Subject: Chamber Construction Manual
Posted by [Clemens Adler](#) on Thu, 25 Mar 2004 08:24:30 GMT
[View Forum Message](#) <> [Reply to Message](#)

I updated the chamber construction manual (to version 1.1).

1) [image001.gif](#), downloaded 2329 times

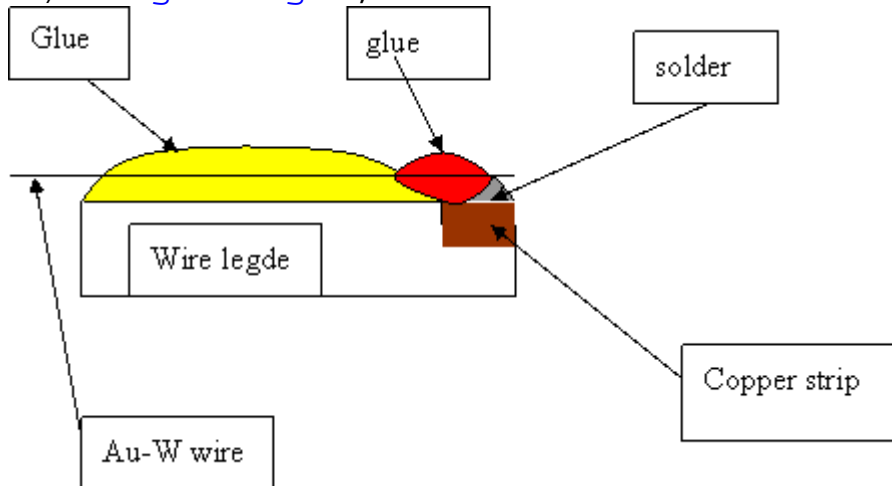
2. An suggestion: Oleg suggests to put some glue to between the glue which holds the anode wire on the wire ledge and the copper strip where the wire is soldered (see attached picture by Oleg).

This should prevent the breaking of the anode wire that we experienced at Heidelberg (see previous messages).

"after soldering of anode wires we put glue (red color) to fix the wire, solder and copper

strip together. It is need to remember that we have to safe a clean place on the copper strip to solder HV cable."

We also had this idea and did it on some chambers, but after discussion with Joerg at GSI, who never had any similar problem we thought that probably sanding the wire ledge edges is good enough and will solve the problem.

Another problem was that we wanted the glue to be cured before we cut the wires, and then we loose 1 day. This is probably not so critical, since at least in Heidelberg and Dubna where not too many people are involved in cahmber building one can find something else to do during this day.

So I would like to hear from GSI (Joerg) and Bukarest (Mihai) what they think. Since we have not put anodes on a chamber since a while due to technical difficulties with machiniery in our lab, I cannot tell at this moment what our experiences with sanding the wire ledges are. I will, therefore, not add this into the construction manual, until there are some more opinions about this additional step.
